MCB Insertion Loss

D2.2 Comment #232

IEEE 802.3dj Task Force
November 2025

Figure 179A-1—Host-Nominal to Host-Nominal, Cable assembly, and test fixture insertion loss at 53.125 GHz

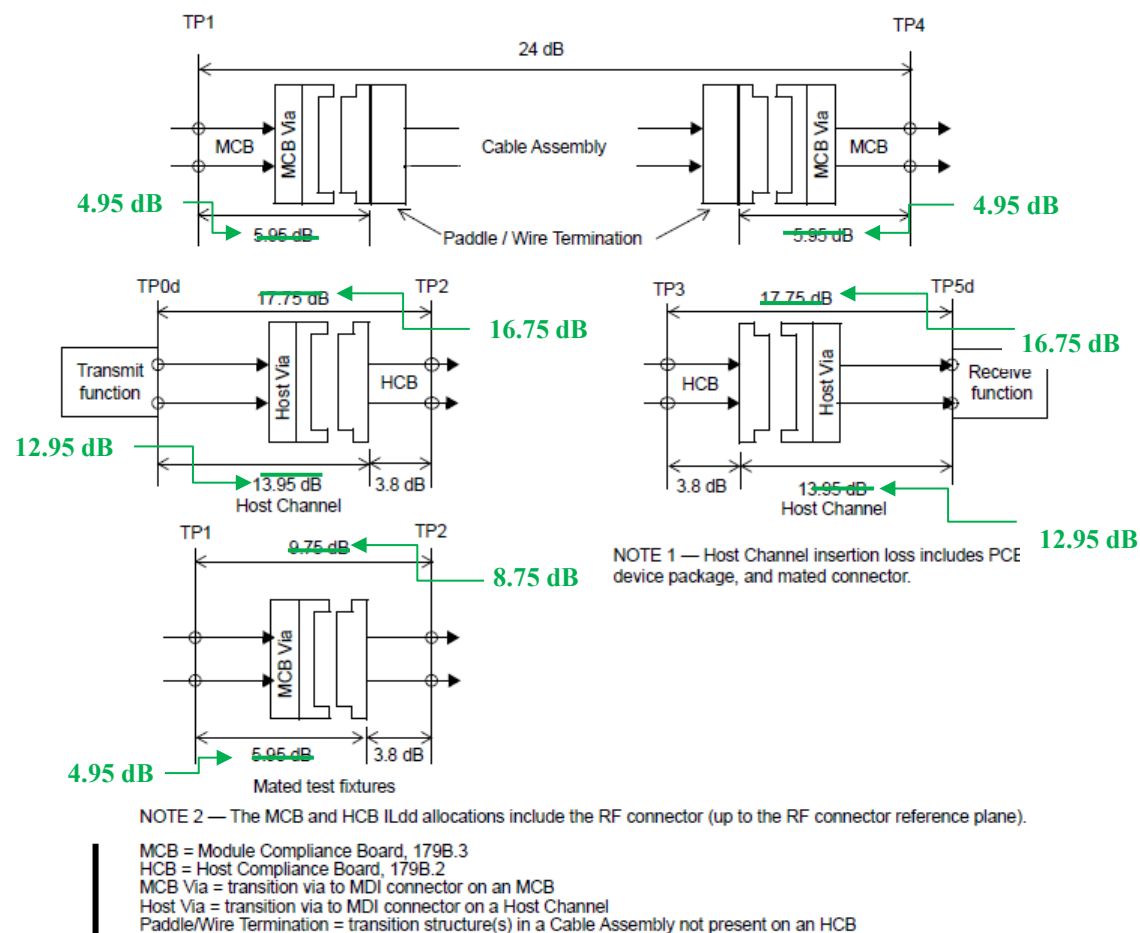
Location	Description
Figure 179A-1	Reduce insertion loss by 1 dB: <ul style="list-style-type: none">• TP1-connector (2x) & connector-TP4 (1x)• TP1-TP2 (1x)• TP0d-connector (1x) & connector-TP5d (1x)• TP0d-TP2 (1x) & TP3-TP5d (1x)
Figure 179A-2	Reduce host channel insertion loss by 1 dB (2x). Modify budget equation to reflect the IL changes.
Table 179A-1	Reduce maximum insertion loss for all 3 host classes by 1 dB for host channels and for TP0d-TP2/TP3-TP5d.
Table 179A-2	For all link configurations in the table reduce <ul style="list-style-type: none">• (Column 3) Ildd_TP0d-TP2,max by 1 dB• (Column 4) Ildd_TP3-TP5d,max by 1 dB• (Column 5) Ildd_MTFref by 1 dB
Table 179A-3	Reduce Ildd_MTFref by 1 dB. Modify budget equation to reflect the IL changes.
Table 176D-3	Change R_peak to account for change in IL (1 dB MCB loss)
Table 176D-6	Change partial host trace lengths to account for reduced connector loss. Comment #204 proposes to change it to 280 mm.

Proposed Changes: Figure 179A-1

Figure 179A-2—HN-to-HN Channel Max (TP0d-TP5d) at 53.125 GHz

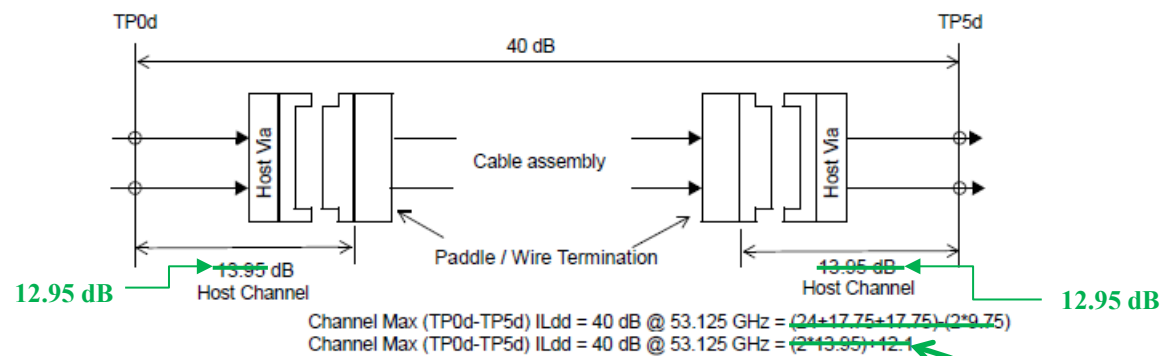
Proposed Changes: Figure 179A-2

Channel Max (TP0d-TP5d) ILdd = 40 dB @ 53.125 GHz = (24+16.75+16.75)-(2*8.75)
 Channel Max (TP0d-TP5d) ILdd = 40 dB @ 53.125 GHz = (2*12.95)+14.1

Figure 179A-3— Channel Min (TP0d-TP5d) at 53.125 GHz

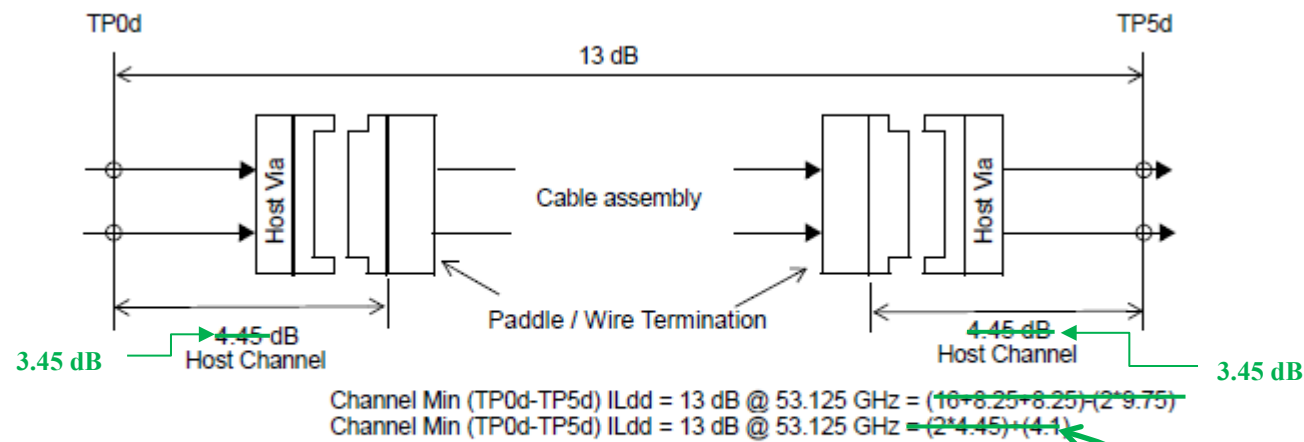
Changes: Figure 179A-3

Channel Min (TP0d-TP5d) ILdd = 13 dB @ 53.125 GHz = (16+7.25+7.25)-(2*8.75)
Channel Min (TP0d-TP5d) ILdd = 13 dB @ 53.125 GHz = (2*3.45)+6.1

Proposed Changes: 179B Equations & Figures

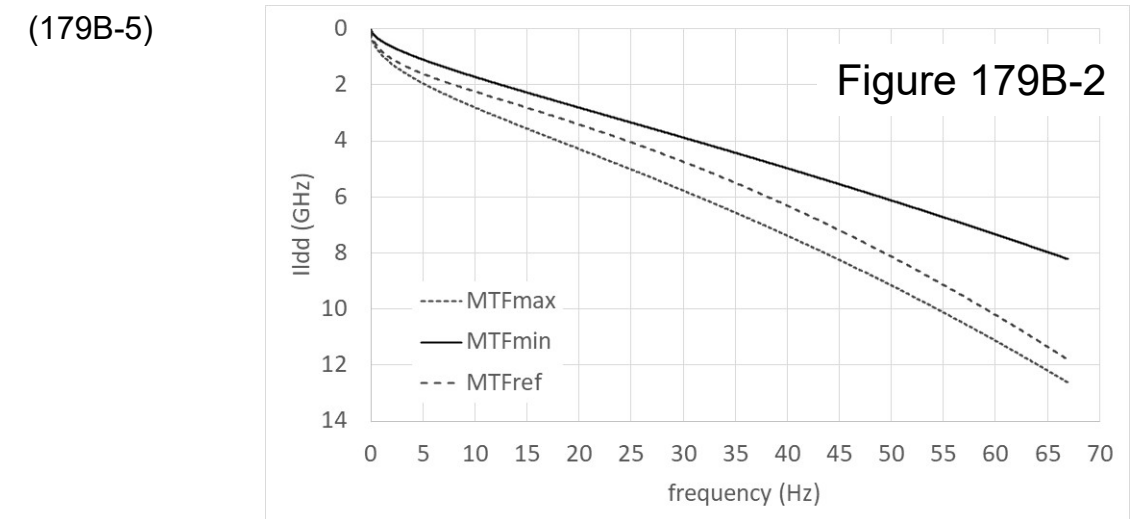
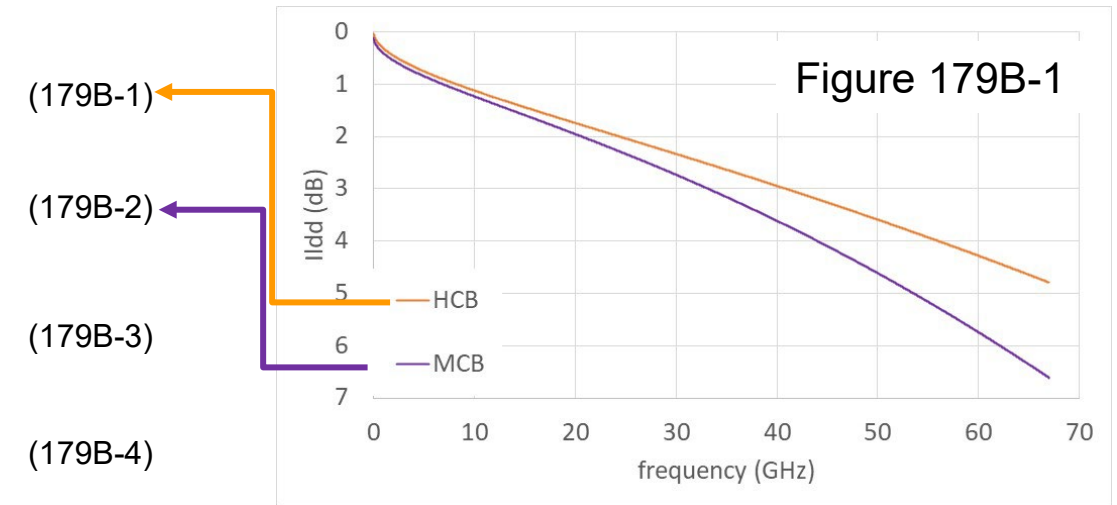
Location	Description
Equation (179B-2)	Modify to reflect change in insertion loss.
Equation (179B-3)	Modify to reflect change in insertion loss.
Equation (179B-4)	Modify to reflect change in insertion loss.
Equation (179B-5)	Modify to reflect change in insertion loss.
Figure 179B-1	Update to reflect change in (179B-2)
Figure 179B-2	Update to reflect change in (179B-3), (179B-4), (179B-5)

- For (179B-1) & (179B-2) refer to healey_3dj_01_2511.pdf
- (179B-5) is the sum of (179B-1) & (179B-2)

$$ILdd(f) \geq ILdd_{MTFmax}(f) = 0.1 + 0.8\sqrt{f} + 0.0055f + 0.00125f^2$$

$$ILdd(f) \geq ILdd_{MTFmin}(f) = 0.3854\sqrt{f} + 0.0455f + 0.00045f^2$$

$$ILdd_{MTFrefTF}(f) = 0.0912 + 0.6175\sqrt{f} + 0.0203f + 0.001091f^2$$
